# DESIGN CHANGE FOR COOLANT PUMP 65468 FROM PLASTIC IMPELLER TO METAL IMPELLER

TECHNICAL INFO NO. 1084

<b>VW</b>	Caddy, Golf III, Polo
<b>Skoda</b>	Octavia
<b>Seat</b>	Arosa

image 1: coolant pump 65468 old design

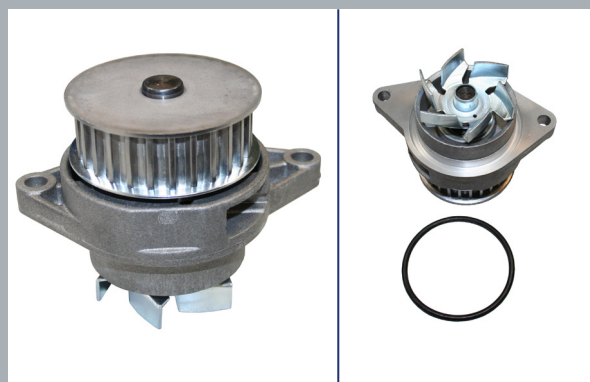
In accordance with the OE stipulations, RUVILLE has changed the design of the named pump from plastic impeller to metal impeller.

During the changeover period, it is possible for mixed stocks of both versions to occur. Both versions comply with the technical requirements and can be used without restrictions for the vehicles stated in the catalogues.
